PREPARED FOR THE PLAN COMMISSION

Project Address: 223 South Pinckney Street (District 4- Ald. Verveer)
Application Type: Demolition Permit, Planned Development Alteration, Conditional Use, and Certified Survey Map
Legistar File ID # [55916](#), [55921](#), [56121](#), & [56288](#)
Prepared By: Kevin Firchow, AICP, Planning Division
Report includes comments from other City agencies, as noted
Reviewed By: Heather Stouder, AICP, Planning Division Director

Summary

Above: West Wilson Street - Lower Levels of Hotel
March 22, 2017 Plans

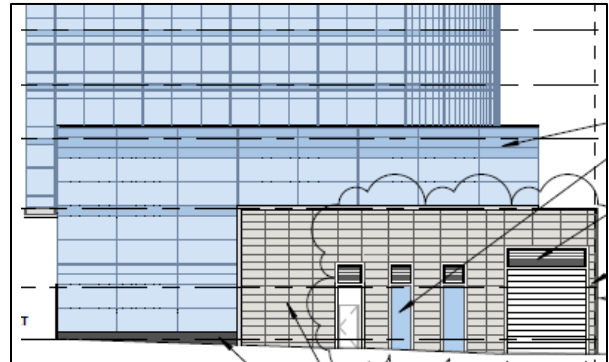
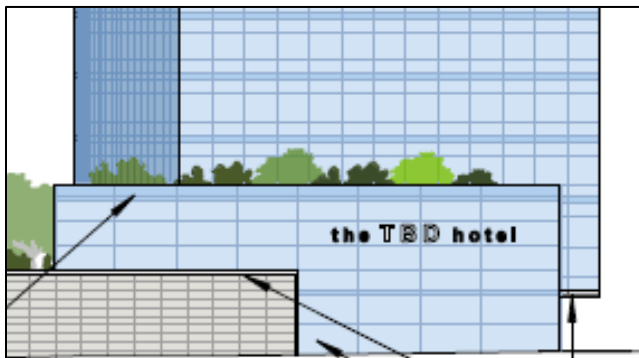
Corresponding façade changes are proposed to the East Wilson and Doty Street facades. Along Wilson Street, the previously approved underground parking entrance is now comprised of a door and spandrel-clad panels. Along Doty Street, additional windows and doors to an enclosed bike parking area are now proposed. No changes are proposed along South Pinckney Street.
